SUNDRY NOTICES AND REPORTS ON WELLS

5. Lease Serial No. NMNM-84633-9984
6. If Indian, Allottee or Tribe Name
7. Unit or CA Agreement Name and No.
8. Well Name and No. Boyd's Canyon 14 Fed Com #1
9. API Well No. 30-015-35290
10. Field and Pool, or Exploratory Area Happy Valley
11. County or Parish, State Eddy NM

PROPOSED PLUG & ABANDONMENT

RE: Plugging and Abandonment Requirements, Conditions of Approval

PROPOSED

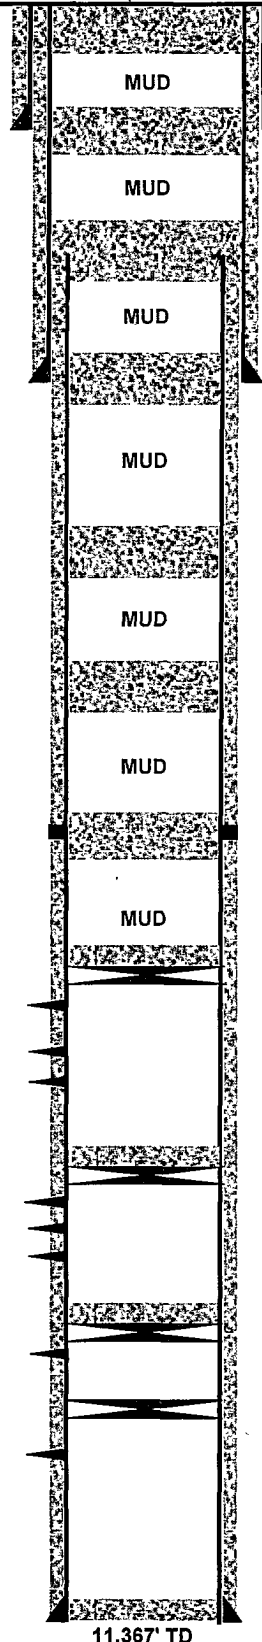
1. OK
2. Prior to setting CIBP, tag existing CIBP at 9715'. 35' is to be dump bailed. If pumping cement, 25sx is required – Otherwise OK (Perfs)
3. Additional cement will be required to get full length. WOC and tag at 7950' or shallower – Otherwise OK (Wolfcamp – DV Tool)
4. OK (Spacer)
5. OK (Bone Spring)
6. Tag at 1950' or shallower – Otherwise OK (Casing shoe – Delaware – BOS)
7. OK
8. Change: Due to cave/karst, a solid plug must be set from 1550' to surface (approx 430sx) – Otherwise OK (Cave/Karst – Stub – Casing shoe – TOS – Surface)
9. Removed: covered in step 8
10. Removed: covered in step 8
11. Verify that all annuluses have cement to surface and fill in as required – Otherwise OK
12. Submit a subsequent report to the BLM.
